## ERRATA\*

### OMISSIONS

## **REVISIONS**

Figure 2-1                  EXPLANATION – Cambrian strata, undivided: change "εq" to "ε"

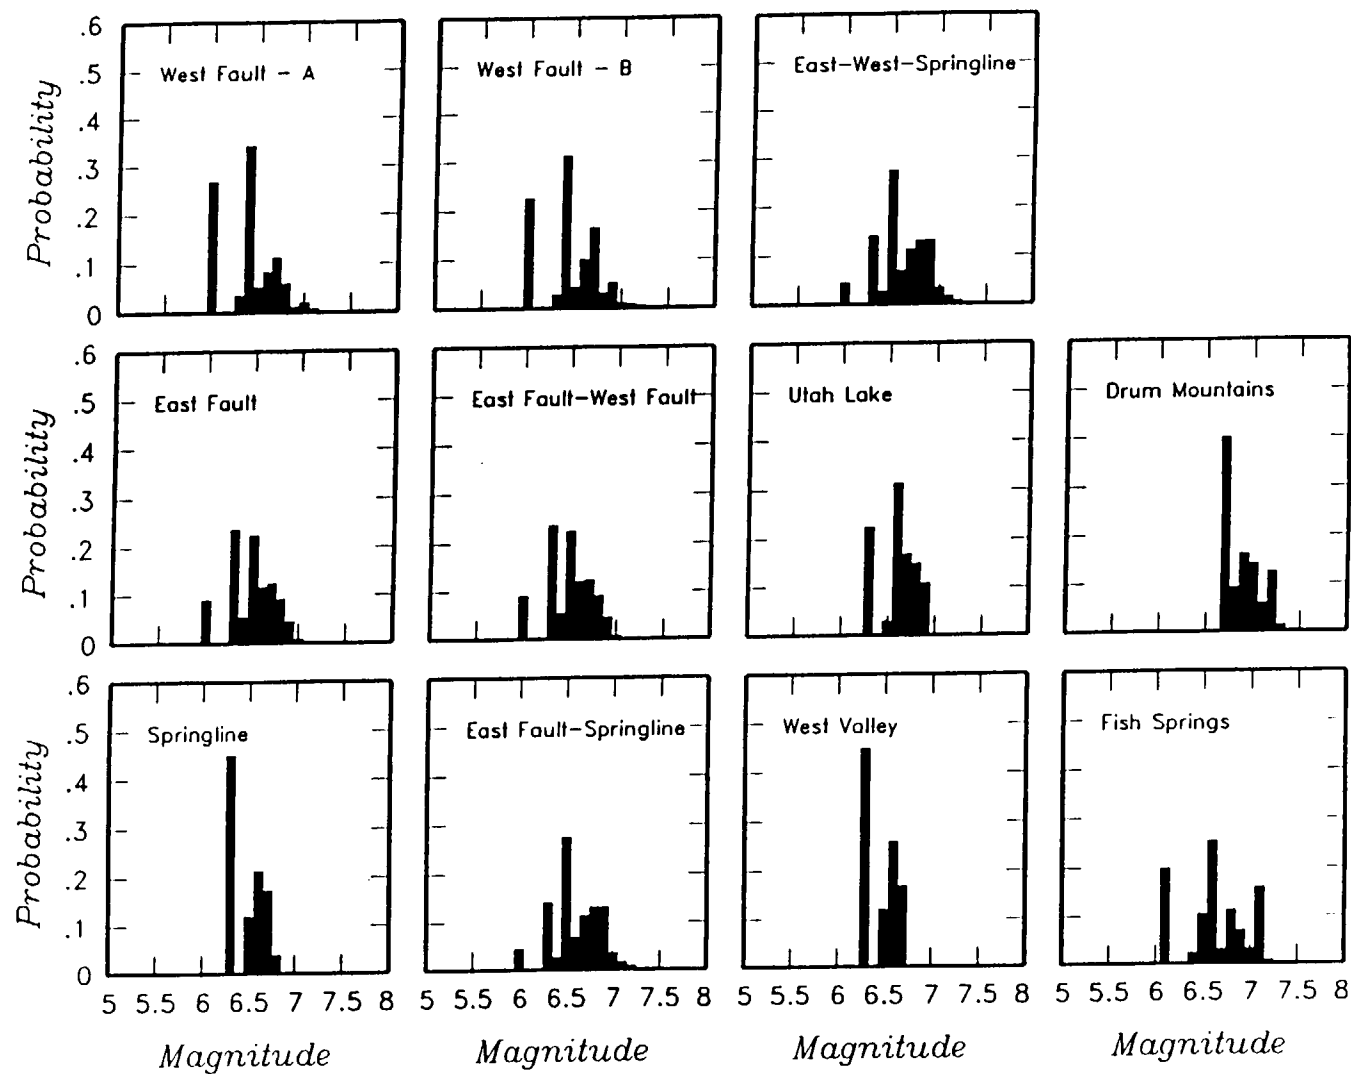
Paleozoic unconformity in hanging wall of West fault should be at topDsd as shown on rest of cross-section (not at top of Ocq).

Figure  
 6-6

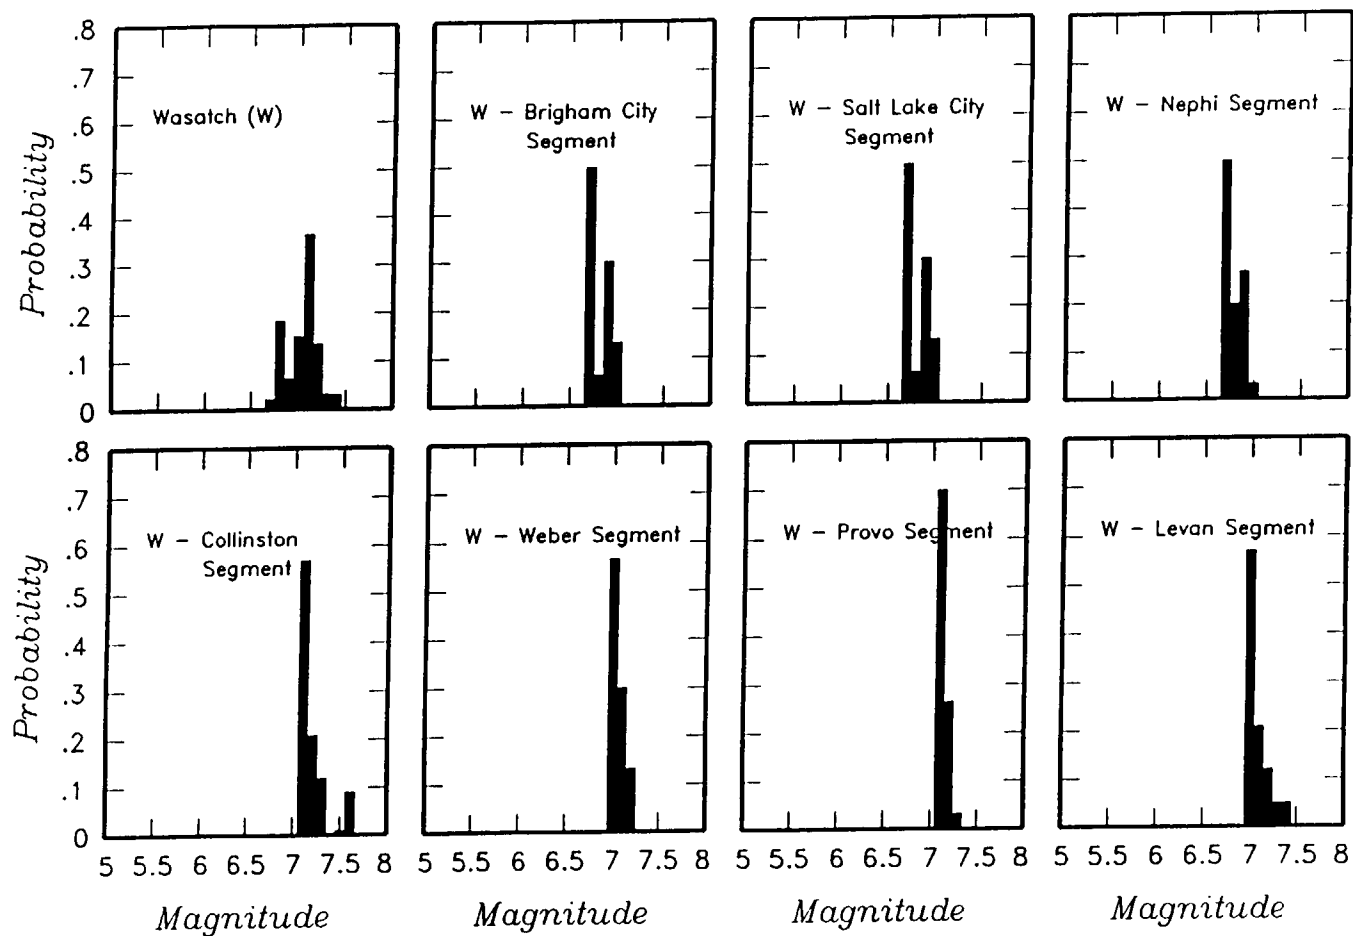
- Figure 6-6, pp. 2 & 3      Maximum magnitude distributions for fault sources.
- Figure 6-9, p. 2              Comparison of horizontal motion attenuation relationships used in the hazard analysis.
- Figure 6-10, p. 1            Comparison of vertical motion attenuation relationships used in the hazard analysis.
